ADDENDUM NO. CC-2

TELEGRAPH DISTRICT
401 BUILDING RENOVATION
LINCOLN, NEBRASKA
DLR GROUP PROJECT NO. 10-16202-00
MARCH 18, 2016

COMBINED CONTRACT

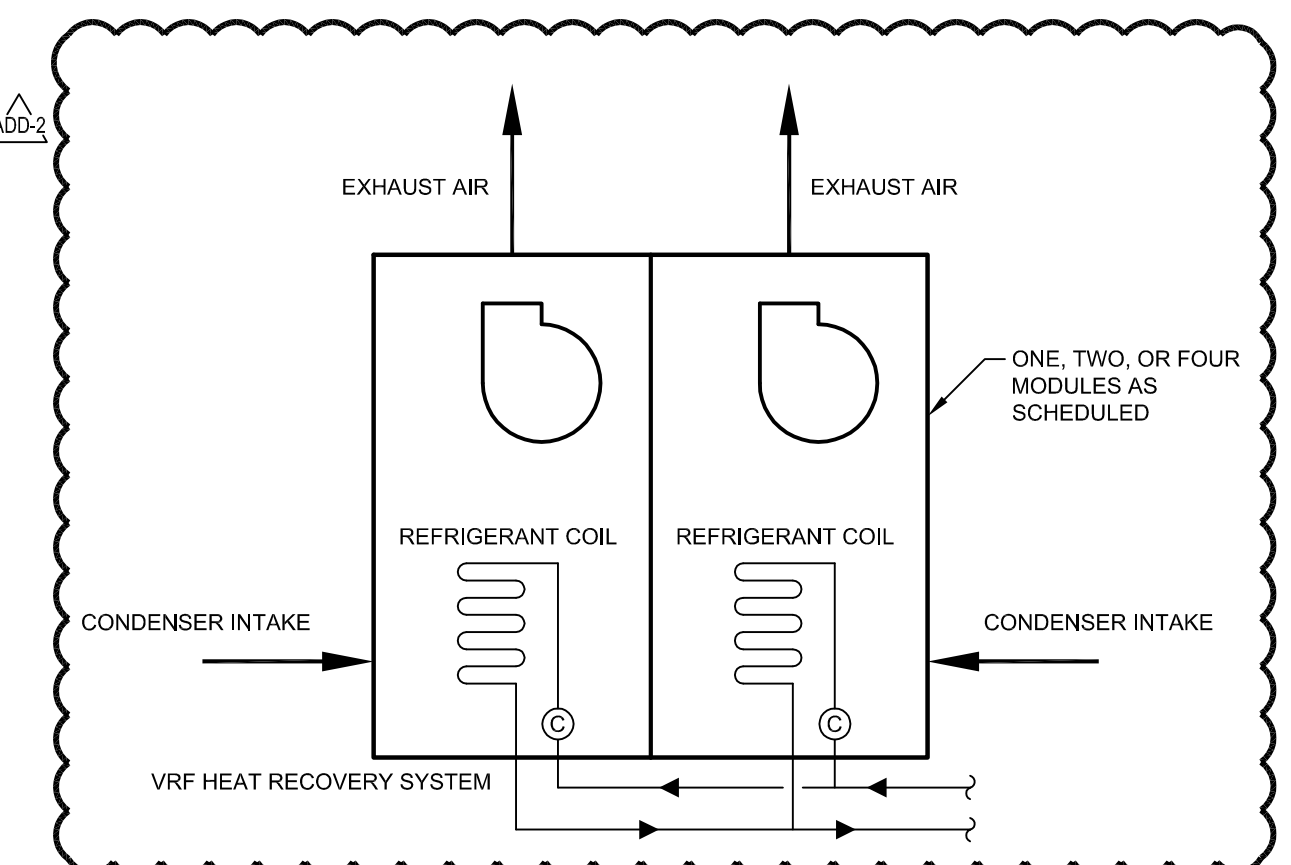
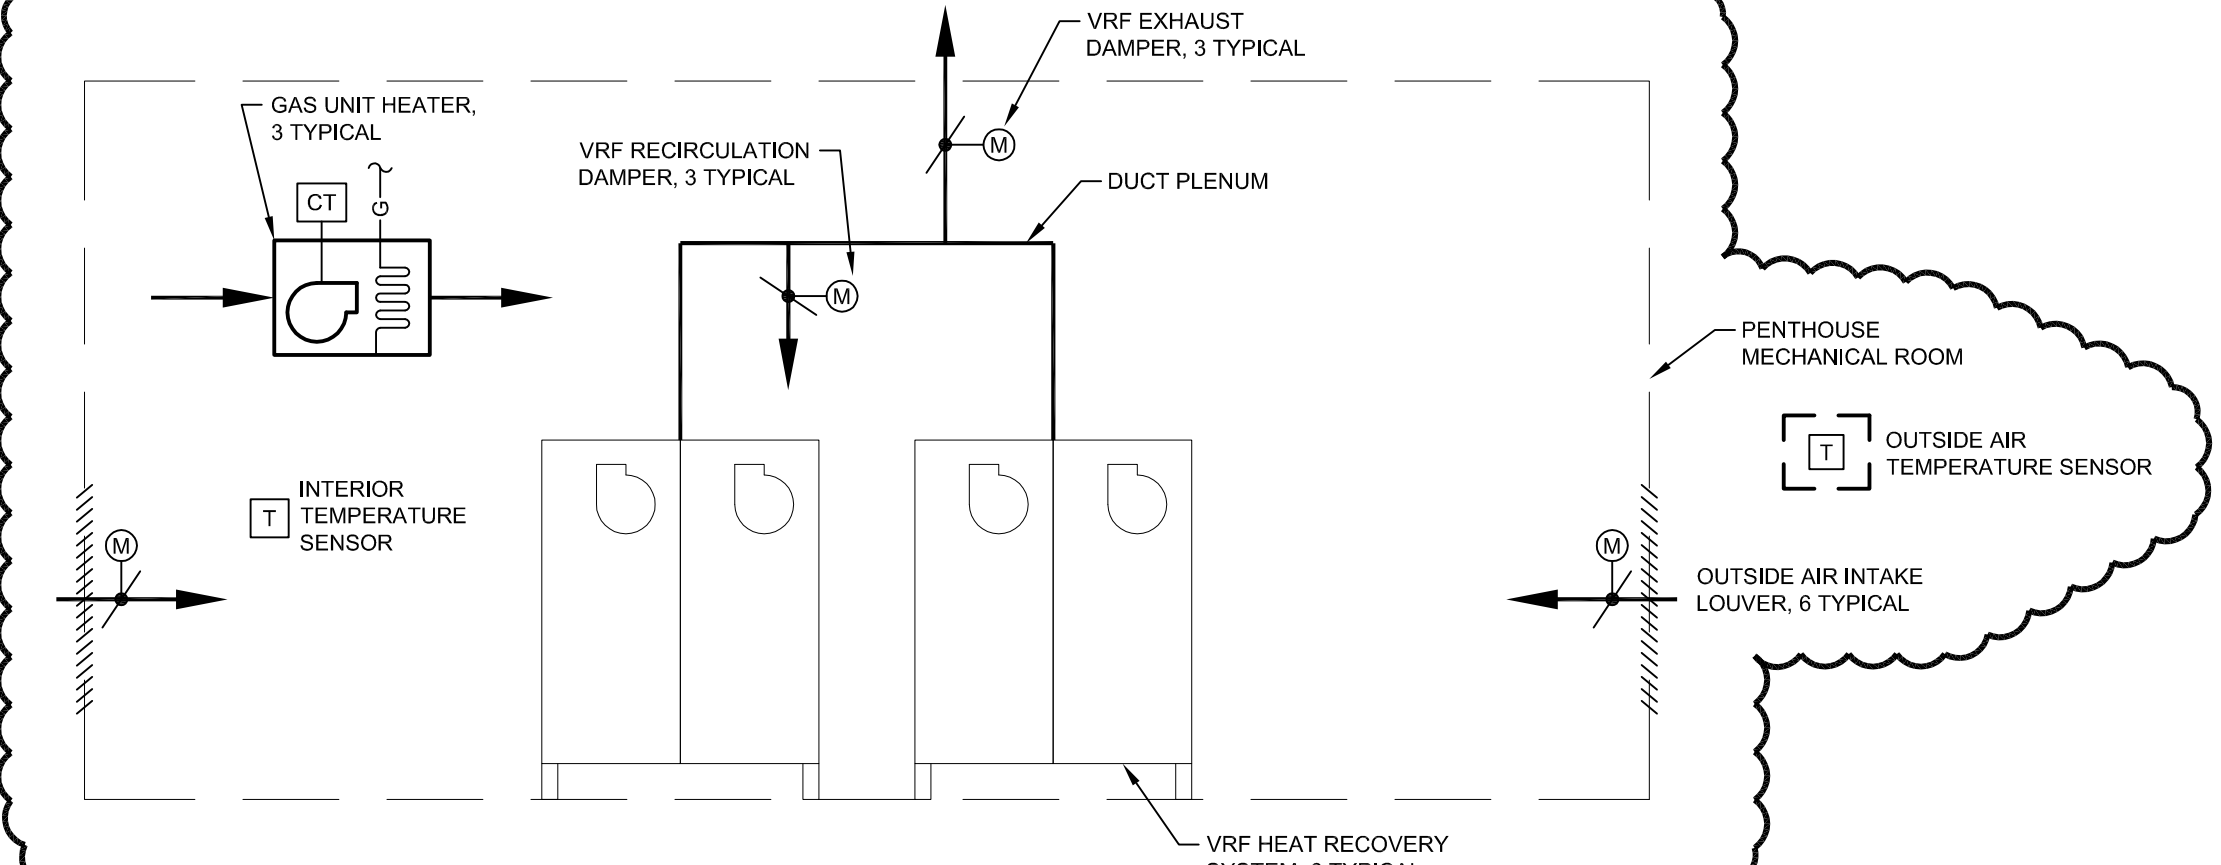
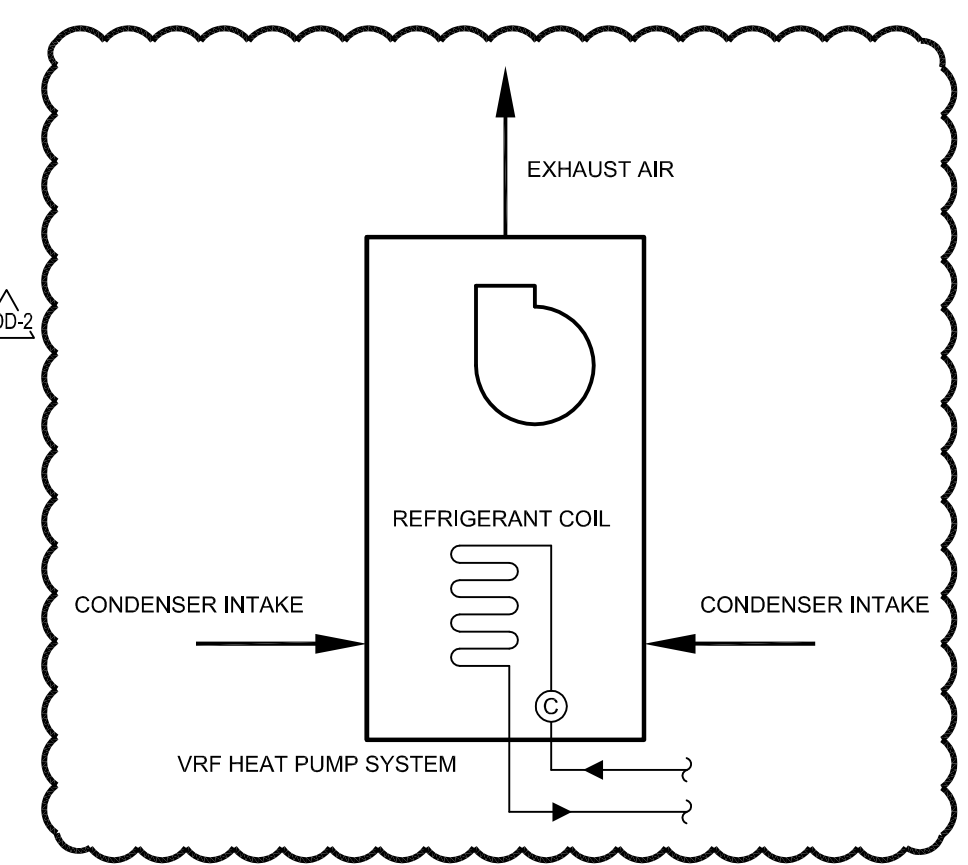
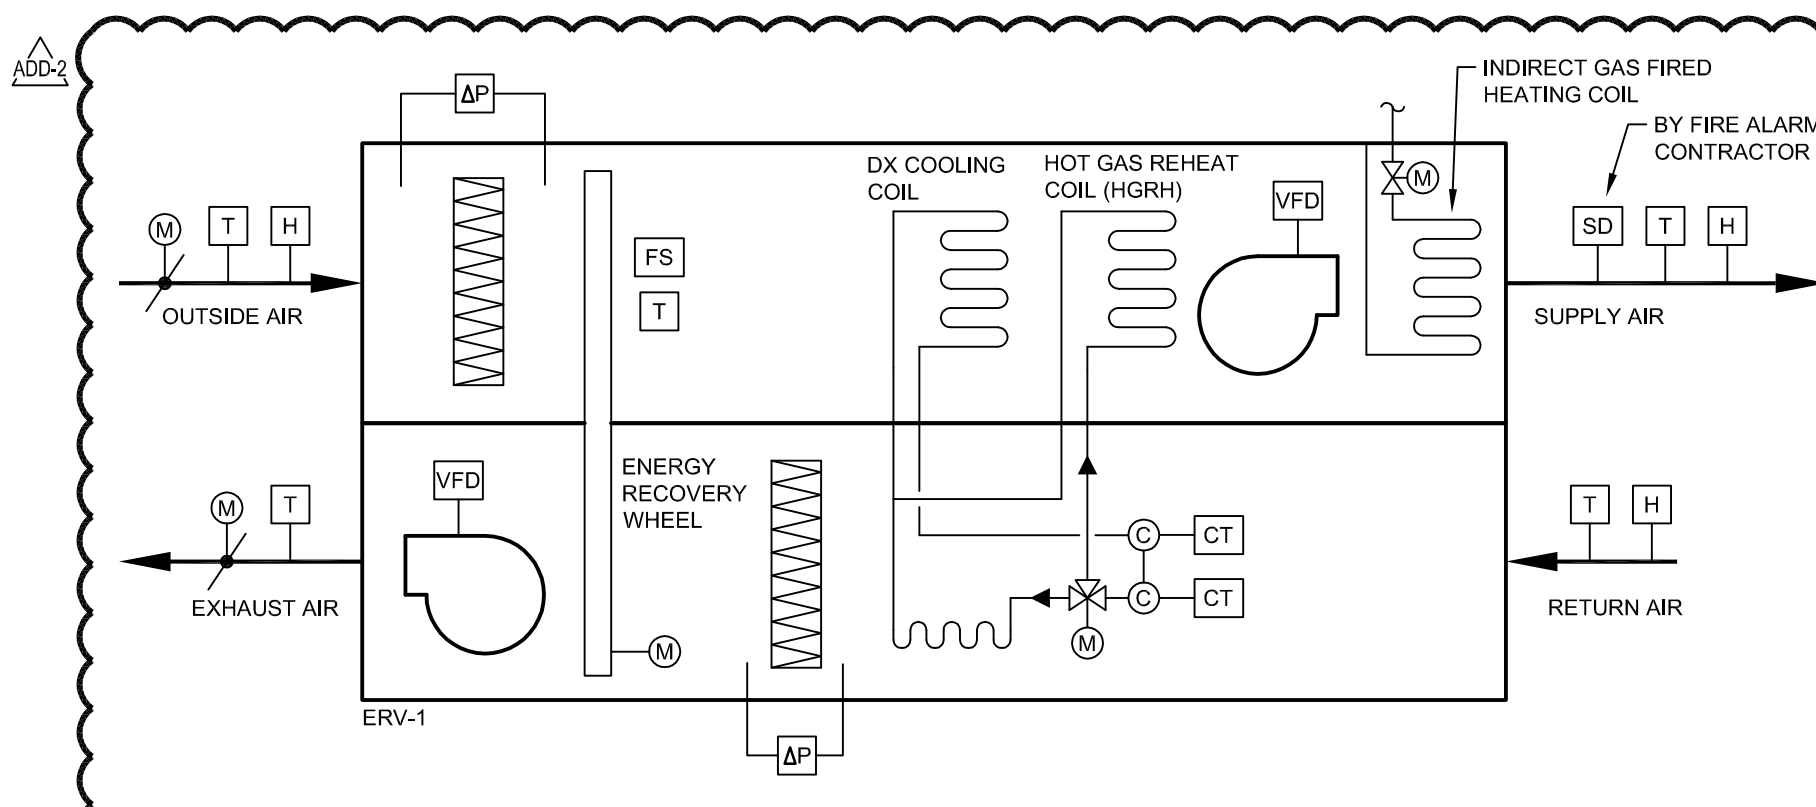
ITEM NO. 17 DRAWING M7.1 MECHANICAL P&ID'S

- A. Revise the drawing as shown in the attachment M7.1 for modifications to the equipment control sequences.
